This Volume presents the results and conclusions of CYJV's technical review of the Three Gorges Project as outlined in the YVPO 1985 Preliminary Design Report and presents the CYJV Recommended Project.

THREE GORGES PROJECT FEASIBILITY REPORT

**RECOMMENDED PROJECT
TYPICAL OPERATION AND ENERGY GENERATION**

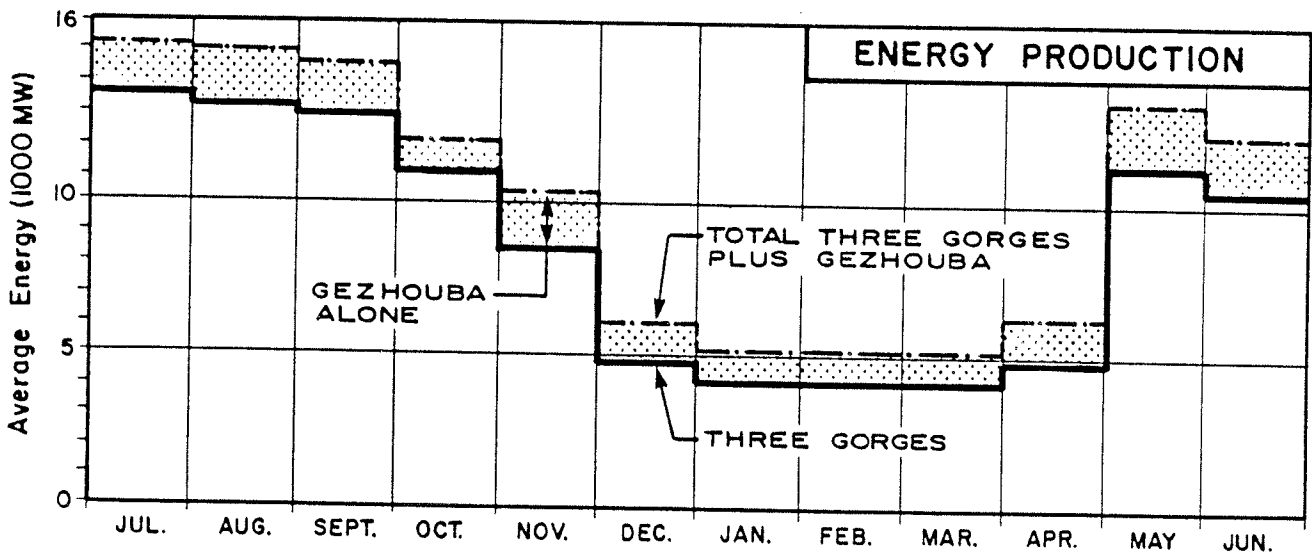
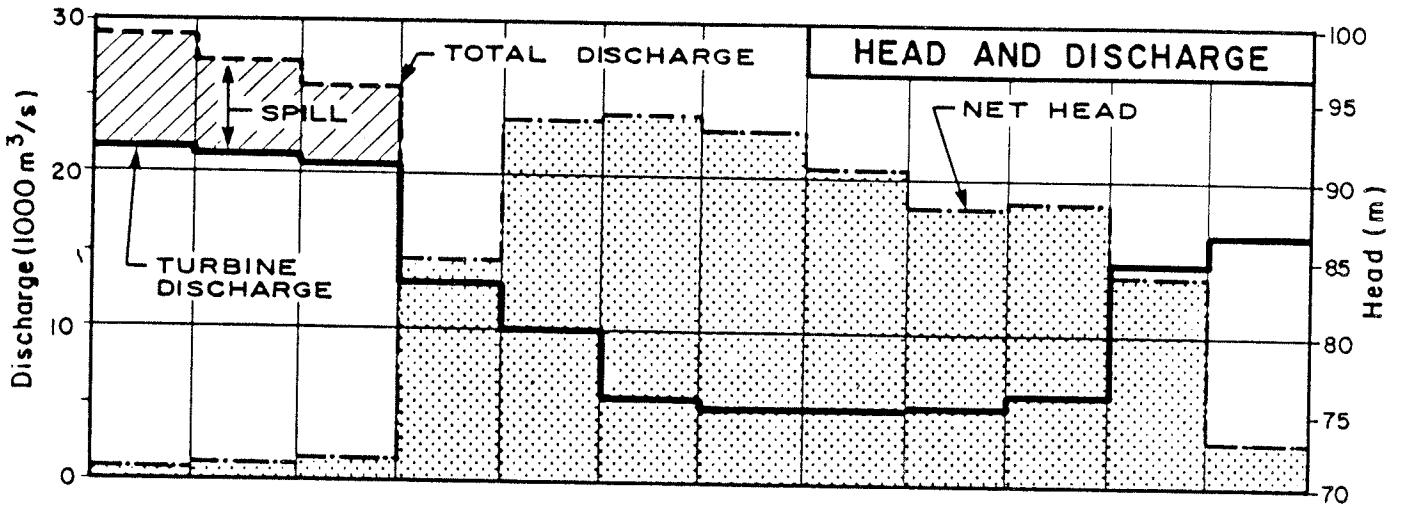
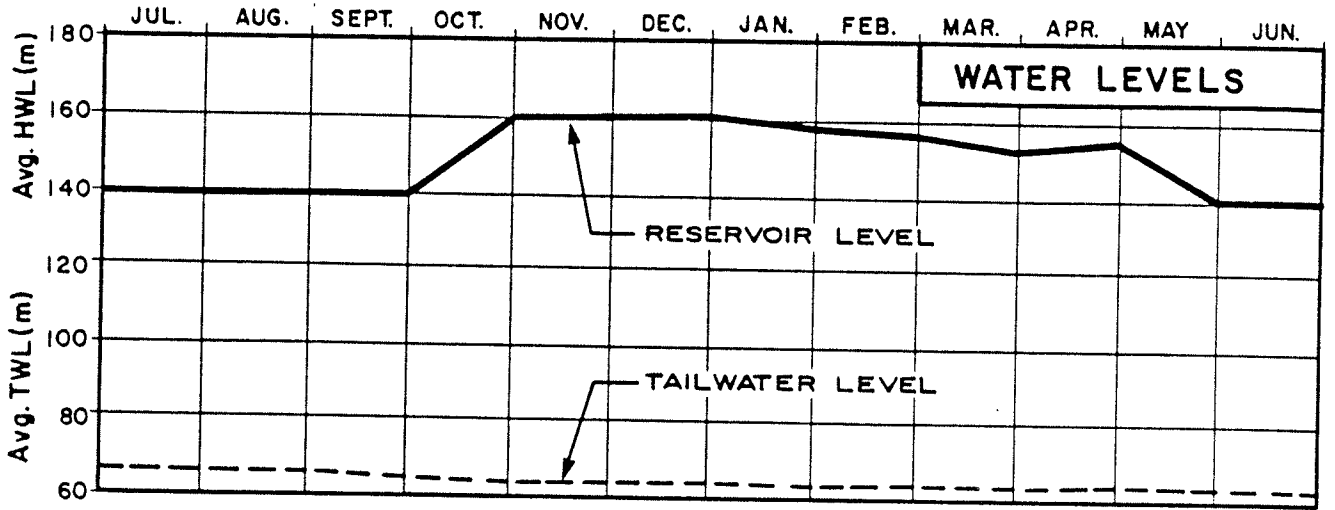
Energy production was simulated by routing the monthly inflows through the reservoir and powerplants, spillway and navigation facilities of both the Three Gorges and Gezhouba Projects. Navigation was assumed to consume 100 m³/s at Three Gorges and 50 m³/s at Gezhouba. As shown in **Figure 1.1**, the reservoir was operated at NPL during the months of November through March except when drawdown is required for flow regulation. During these months, the reservoir was lowered as required to regulate flows for firm energy production and for navigation downstream. During May it was lowered uniformly from the NPL to the FCL. From June through September, during the flood season, the reservoir was held at the FCL to flush sediments through the reservoir, except when it was filled above the FCL in the process of regulating flood inflows to provide flood protection downstream. During October the reservoir was filled uniformly from the FCL to the NPL.

THREE GORGES PROJECT FEASIBILITY REPORT COMPARISON OF ALTERNATIVE LOCK ARRANGEMENTS

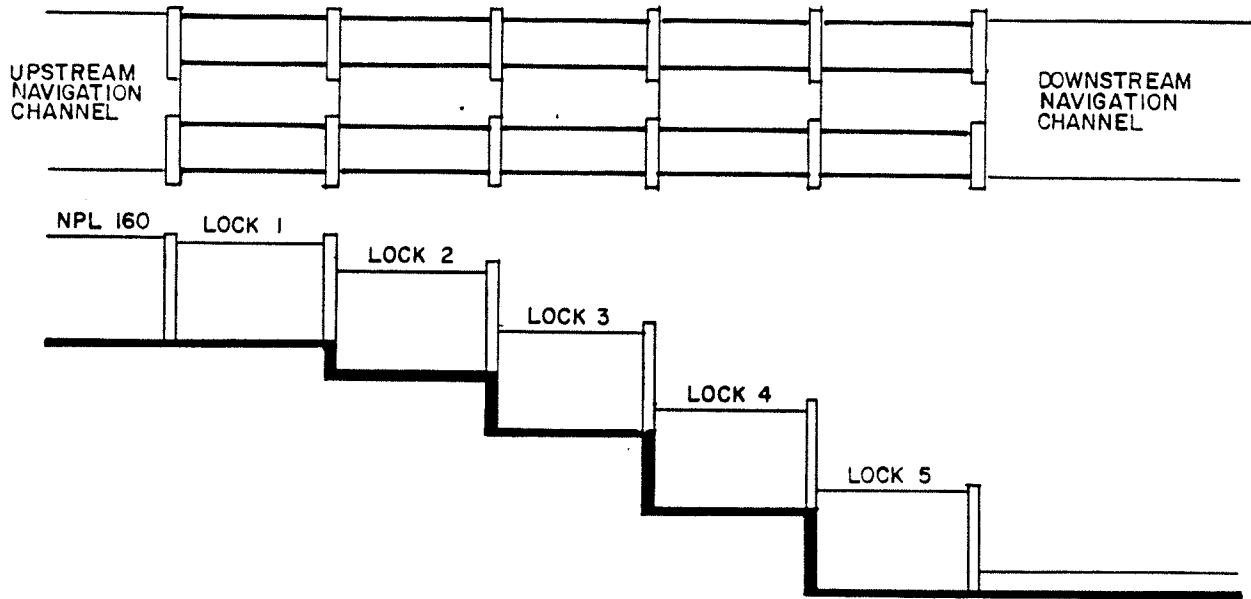
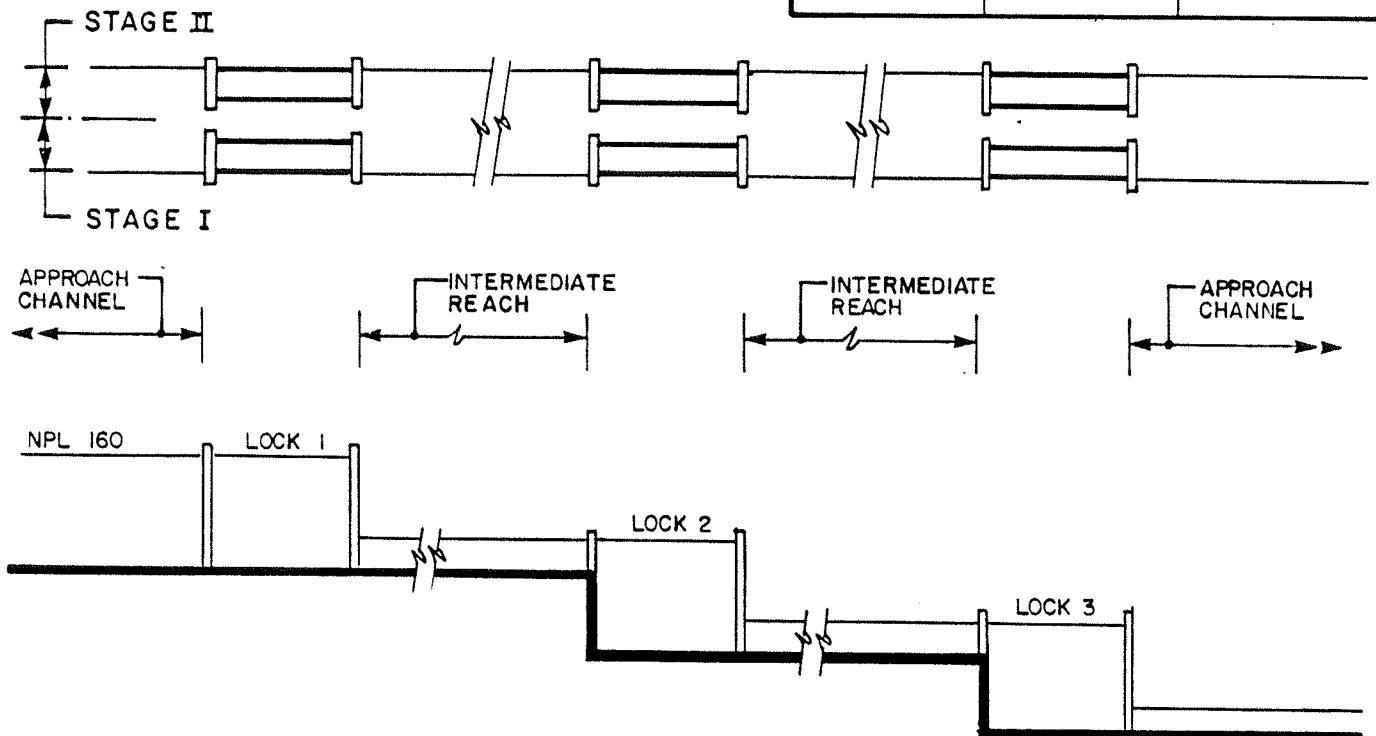
These alternatives have about the same capacity. The cost of the separate locks in series would be about 21% higher. If low demand occurs for the first 10 to 15 years of operation the separate locks are economic with staged construction. Single locks could be constructed initially and twinned later as the demand grows. If flight locks are used, staging is not feasible as each flight must be operated in one direction only to achieve reasonable efficiency. Therefore flight locks must be twinned from the outset.

The costs for these alternatives with NPL 160 would be as shown on **Figure 1.2**. If distances greater than shown on **Plate 4.23** are required between the separate locks, the cost of the separate lock alternative would increase above those shown on **Figure 1.2**.

As there is uncertainty concerning the MOC criteria for separate locks and the demand forecast during the first few years of operation, the five-stage flight lock alternative has been selected.
